STAFF REPORT: JULY 10, 2024 MEETINGPREFAPPLICATION NUMBER: HDC2024-00229ADDRESS: 2310 EDISONHISTORIC DISTRICT: BOSTON EDISONAPPLICANT: JONATHAN TAYLORPROPERTY OWNER: JONATHAN TAYLORDATE OF PROVISIONALLY COMPLETE APPLICATION: JUNE 18, 2024DATE OF STAFF SITE VISIT: MAY 22, 2024

SCOPE: REPLACE WINDOWS (WORK COMPLETED WITHOUT APPROVAL)

Façade

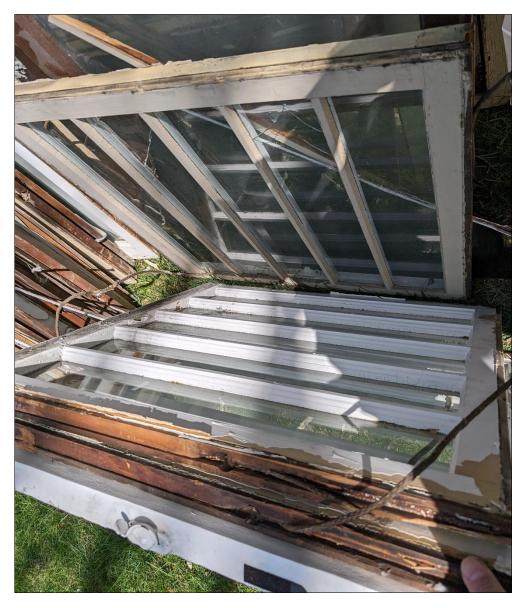
• Work crew finishing up last few windows at porch upon arrival to site, advised to stop work and restore wooden windows.
 Original historic wooden windows on all four elevations have been replaced with beige vinyl units, some of them with between-glass grids.

• Inspected historic wood sash stacked in front yard, all of which appeared to be in good repairable condition
• Crew's work trucks marked with "Robert's Installation" from Oxford and Troy, MI. Claimed to be a sub hired by contractor responsible for permitting.

• Advised property owner to retain historic sash for later reinstallation, they were placed in garage by contractor's workers
 Contractor (phoned by on-site crew chief) self-reported as Scott Kraiza ("My Quality Construction" of Warren, Michigan), stated he had applied for a permit, HDC staff found no record of application in Accela
 No record of application or communication with HDC
 Mr. Kraiza said he was unable to provide GC license number or permit application number
 Discussed HDC application process and deadlines for June/July meetings with owner and his attorney, who stated that they would contact hdc@detroitmi.gov to review application requirements
BSEED had not yet arrived when HDC staff left site

Staff photos, removed window sash.

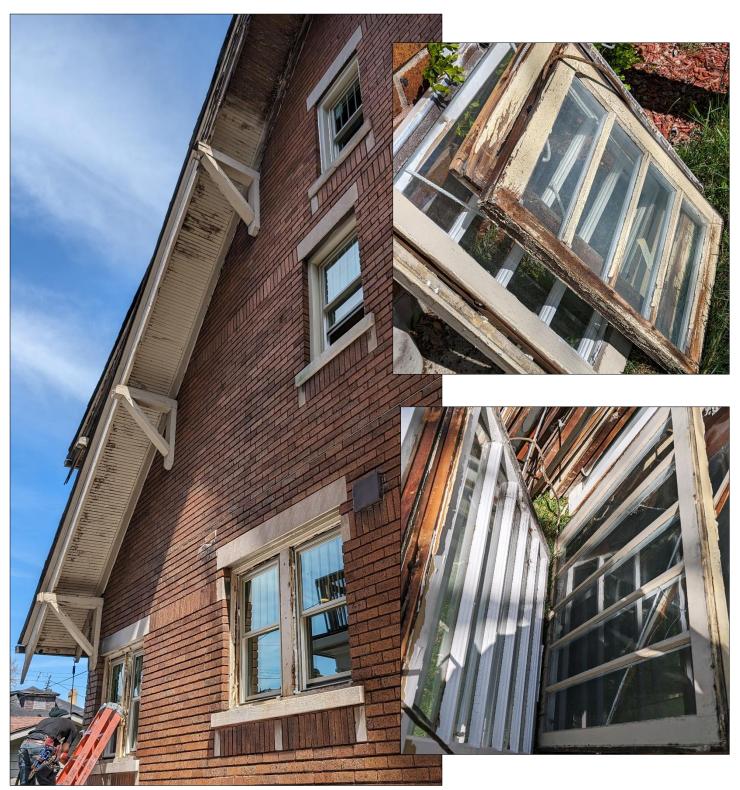
The application did not provide sufficient documentation outlining the deterioration of the original wood windows that were removed without approval. Based on staff's site assessment and the photographs of the removed windows, it is staff's opinion that the window sash were intact prior to removal and the wood frames and glass panes appeared to be in repairable condition.

As the windows were removed without Historic District Commission approval; based on the Standards, new windows should match all the details of the historic windows that were removed. In this instance, the wood windows that were removed should be repaired and reinstalled within their respective window openings.
